Subject: INFORMATION DISPLAY SHOWS "FOW INSPECTION REQUIRED" AND DTC C1A67:78 IS STORED	Bulletin No: 01-016/14
	Last Issued: 07/08/2014

- This bulletin supersedes the previous bulletin 01-029/13, issued on 11/27/2013. The REPAIR PROCEDURE, PART(S) and WARRANTY INFORMATION have been revised.
- Changes are noted below in Red beside the change bar.

Figure 1: Subject for VCM reprogramming

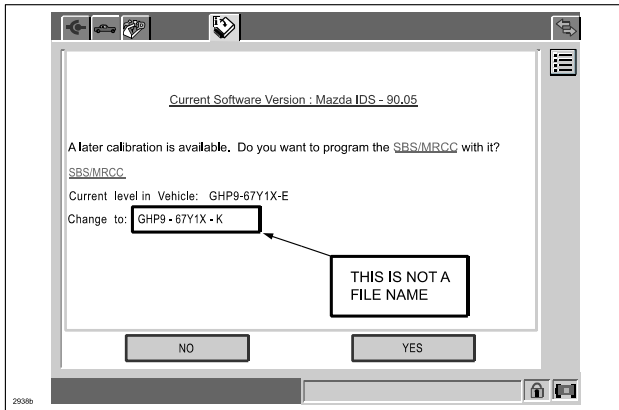
- b. Either of the following screens (Figure 1 or 2) is displayed.
- If the Figure 1 is displayed, the VCM is before the latest calibration. Click “YES” and follow the M-MDS instructions to reprogram the VCM.
 - If the Figure 2 is displayed, the VCM is already the latest calibration. This Service Information does not apply and refer to Workshop Manual for troubleshooting and repair.

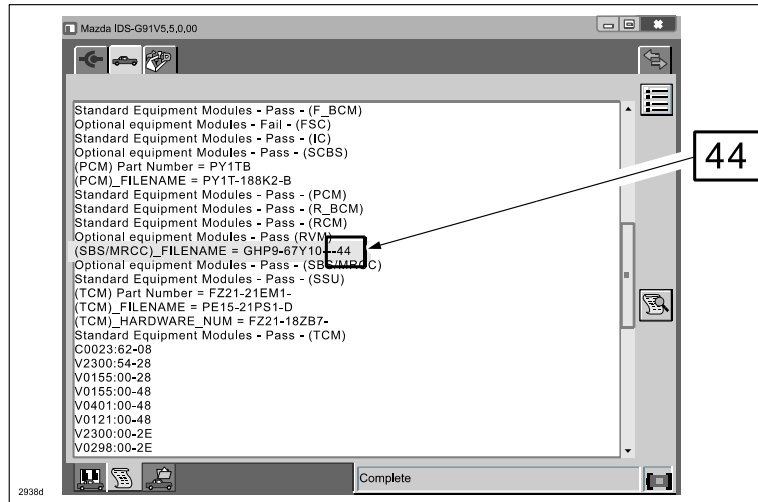
- c. After reprogramming, close the session. Then, open a new session and go to the “Log Viewer” screen. The programmed file name is displayed as shown in figure below. If the last two letters are “44”, the reprogramming has been successfully completed.
